APPLICATION NO.	FILING DATE	FIRST NAMED INVENTOR	ATTORNEY DOCKET NO.	CONFIRMATION NO.
10/711,326	09/10/2004	Takahiro Nakano	S1C-04-034	5325
29863	7590	07/09/2010	EXAMINER	
DELAND LAW OFFICE P.O. BOX 69 KLAMATH RIVER, CA 96050-0069				IRVIN, THOMAS W
ART UNIT		PAPER NUMBER		
3657				
			NOTIFICATION DATE	
			DELIVERY MODE	
			07/09/2010	
			ELECTRONIC

<b>Office Action Summary</b>	<b>Application No.</b>	<b>Applicant(s)</b>
	10/711,326	NAKANO ET AL.
	<b>Examiner</b>	<b>Art Unit</b>
	THOMAS IRVIN	3657

## DETAILED ACTION

Fig. 4 (US 3,168,836)

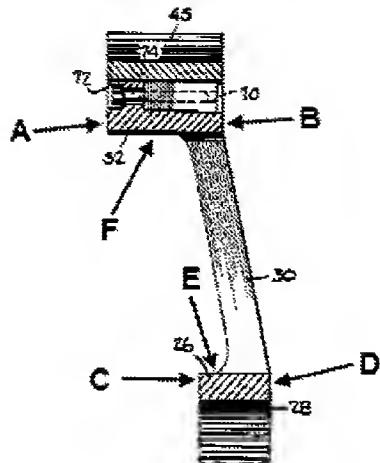
In Re claim 13, Militana discloses, with reference to fig. 4 above, a sprocket comprising: a sprocket body (20); a plurality of teeth (45); a radially inwardly and outwardly extending spline (28), wherein the spline has a root portion (30) and a radially inner portion (26) having a side wall (C,D); wherein the spline terminates at a free end (26); and wherein a thickness of the radially inner portion (26) is greater than a thickness of the root portion (30). Examiner notes that the radially inwardly extending spline and radially outwardly extending spline are understood to be the protrusions and corresponding depressions of the spline.

In Re claim 14, see side wall (A), first side wall portion (24), teeth (45), and root portion (32).

In Re claim 18, the sprocket is understood to meet the limitations of being one-piece when fully assembled (see fig. 1).

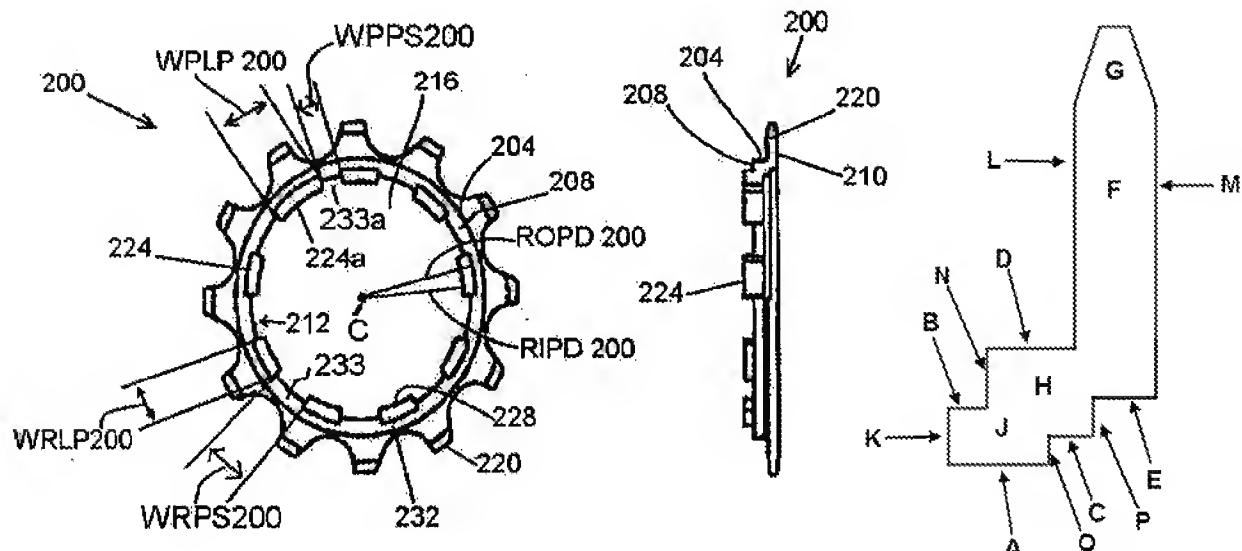
In Re claim 13, Kamada et al. disclose, with reference to figs. 3A and 3B above, a sprocket comprising: a sprocket body (200,F); a plurality of teeth (G); a radially inwardly and outwardly extending spline (A, C), wherein the spline has a root portion (H) having side walls (N,P) and a radially inner portion (J) having side walls (K, O); wherein the spline terminates at a free end (K); and wherein a thickness of the radially inner portion (J, K-O) is greater than a thickness of the root portion (H, N-O). Examiner notes that the radially inwardly extending spline and radially outwardly extending spline are understood to be the protrusions and corresponding depressions of the spline.

In Re claim 14, the sprocket has a side wall (M) and first side wall portion (F), wherein the plurality of teeth (G) extend from the first side wall portion, and wherein a

thickness of the first side wall portion (L-M) substantially equals a thickness of the root portion (H, N-L, L-M).

In Re claim 18, Kamada et al. disclose that the sprocket is one-piece.

In response to applicant’s arguments regarding the 102(e) rejection to Kamada et al., the examiner has now attempted to clarify the rejection by additionally identifying the side walls (N,P) of the root portion.
